## KIDDE RESIDENTIAL AND COMMERCIAL SERVICE BULLETIN #007

**SUBJECT:** Kidde 10 lb. Dry Chemical Fire Extinguishers with Black Zytel® Nylon Valves and Steel Cylinders

**DATE:** July 15, 2004

### Identifying the affected models

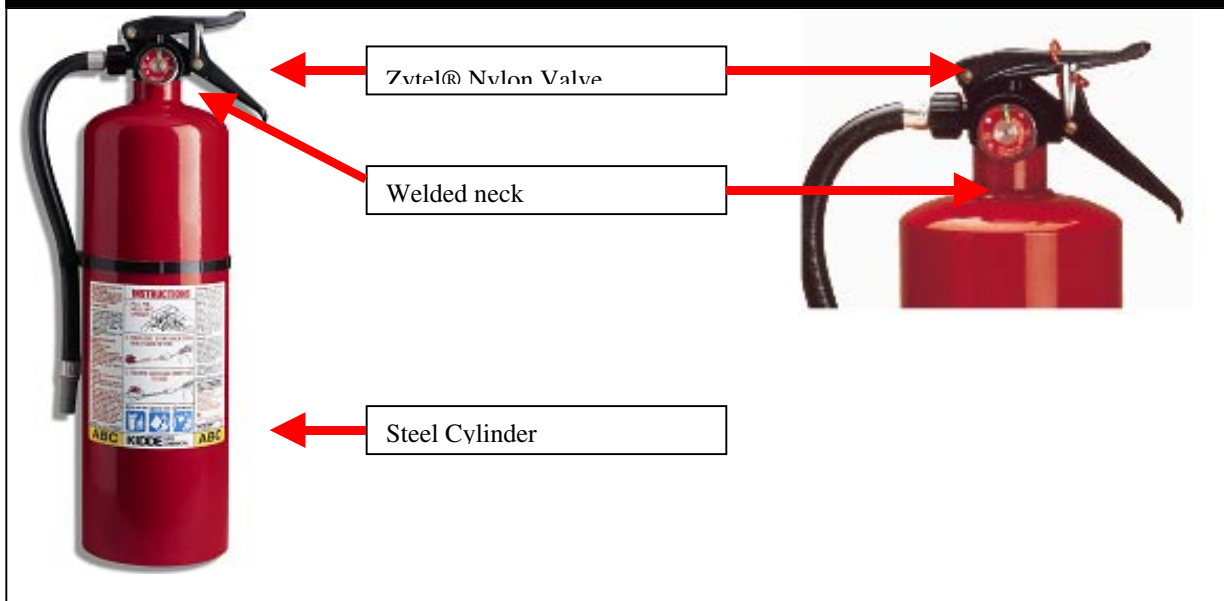
**Identification of Applicable Fire Extinguisher Models:** All Kidde 10 lb. dry chemical fire extinguisher models that utilize a black Zytel® nylon valve assembly and a welded steel neck collar cylinder and which were manufactured between 1991 and 2000 are covered by this bulletin. These units are primarily designed for commercial and industrial applications, and the vast majority will be found in businesses and other commercial spaces, as they require service by a fire extinguisher service company. These models can be visually identified by comparing them to the images below.

**ONLY MODELS HAVING THE SAME TYPE OF WELDED TOP CYLINDER NECK COLLAR SHOWN ARE SUBJECT TO THIS BULLETIN. SUBJECT MODELS ALSO HAVE A TOTAL HEIGHT OF BETWEEN 20 TO 21 INCHES.**
